# Amendment #A00004 - PreBid Clarifications

PROJECT: UPGRADE UNDERGROUND UTILITIES – TEMPLE VAMC  
VA PROJECT NUMBER: 674-10-101  
BID DATE: 06-05-14

**1 UTILITY TUNNEL PLAN - SEGMENT D**  
SCALE: 1" = 20'

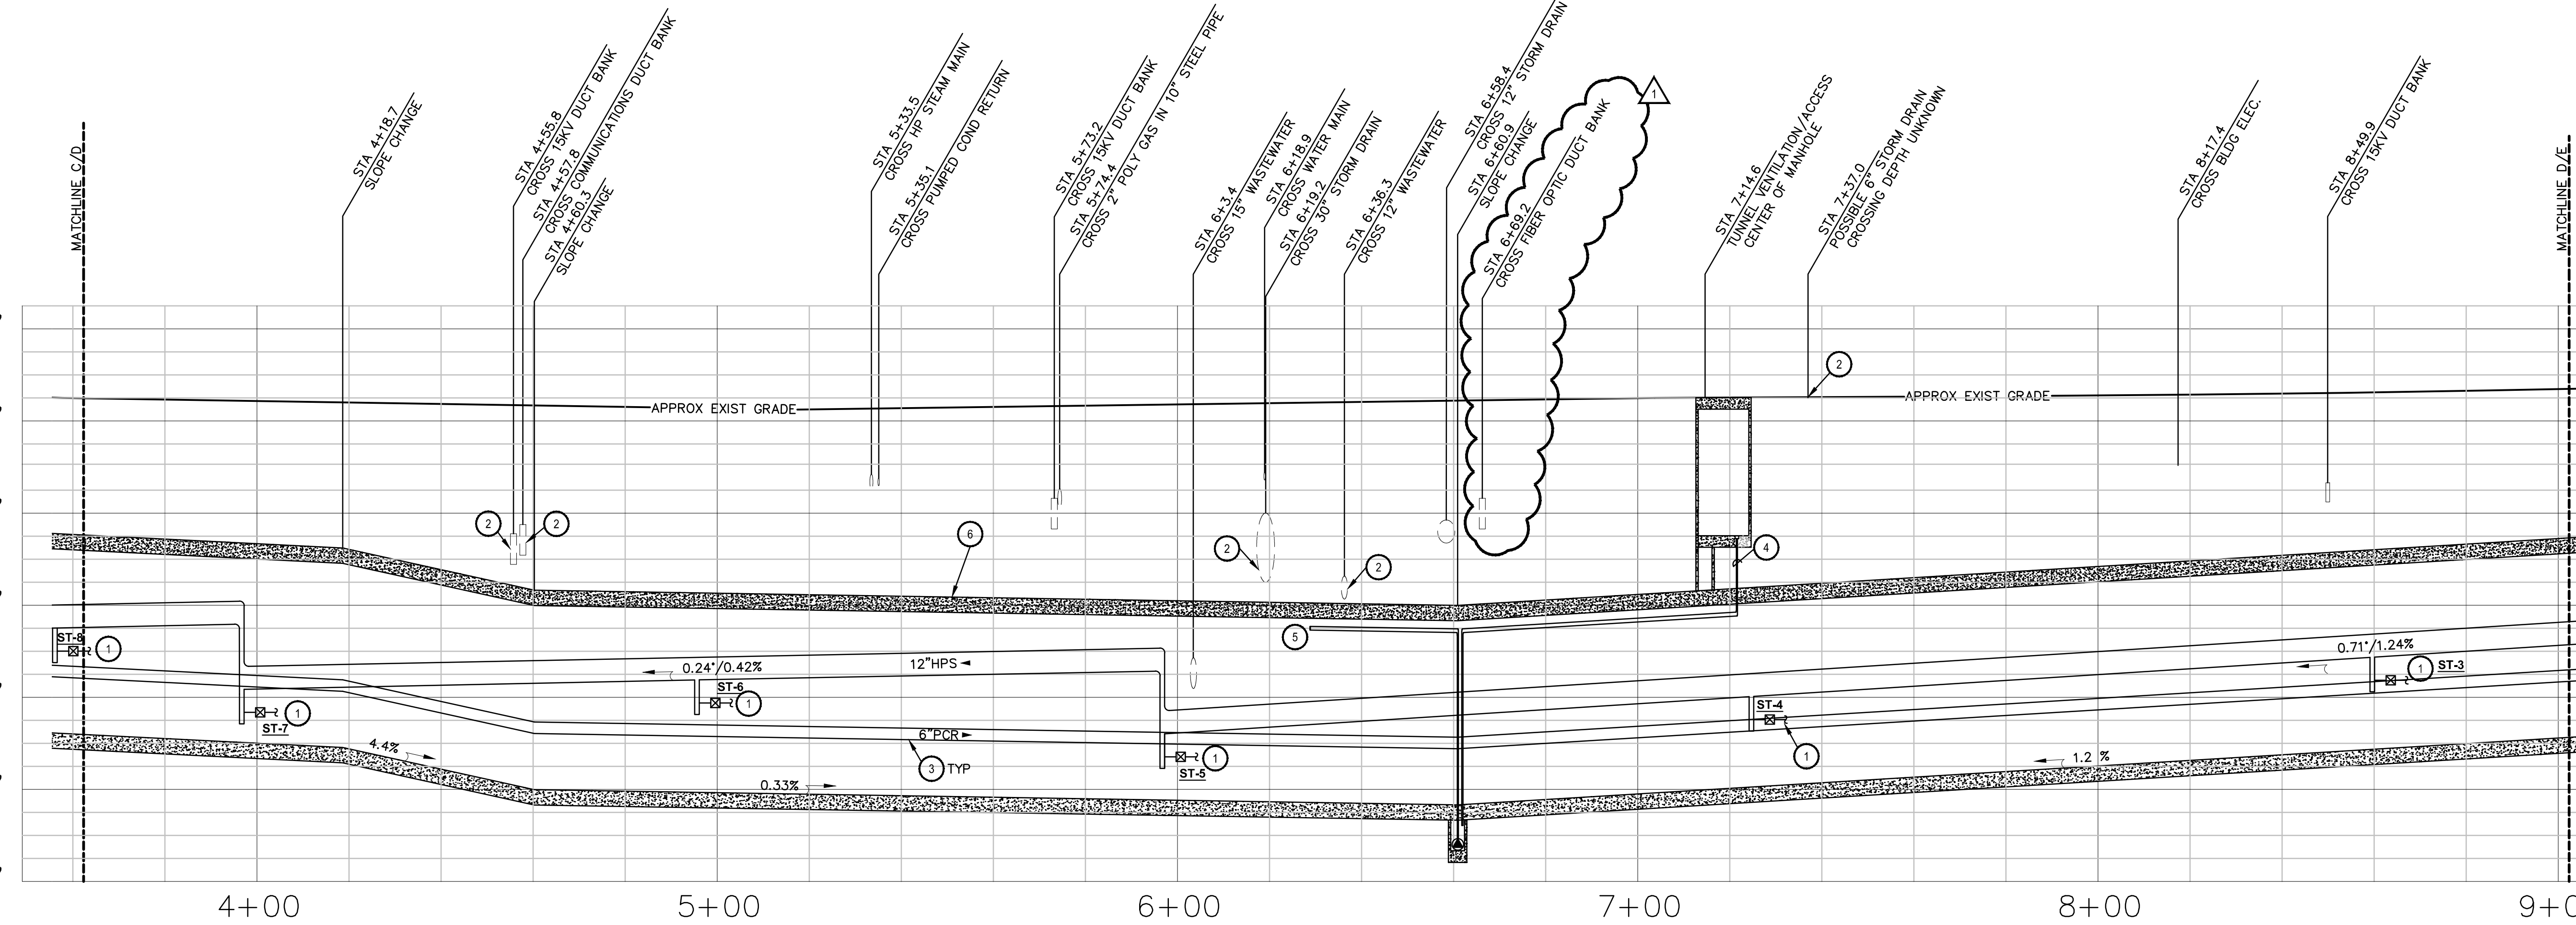
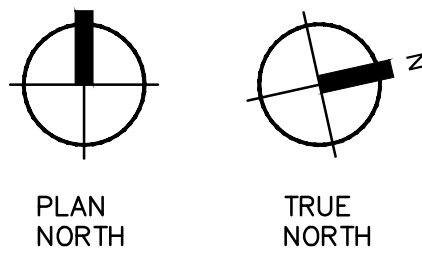
1. Sheet M1.1: Revise scheduled voltage for Pump SP-1 to 230/1/60.
2. Sheet CU1.2, Detail 1: Between approximate stations 6+25 and 7+75 contractor shall remove four (4) existing light fixtures, poles, piers and associated wiring if / as required to construct tunnel. After tunnel construction, contractor shall reinstall these items equivalent to their original installation and location.
3. Sheet MS3.4, Detail 2: Revise breaker callout to read 20/2 in lieu of 20/1.
4. Sheet CU1.2, Detail 1 & D: Revise the existing fiber optic conduit layout per the attached drawing and protect the line as required to install the new tunnel.
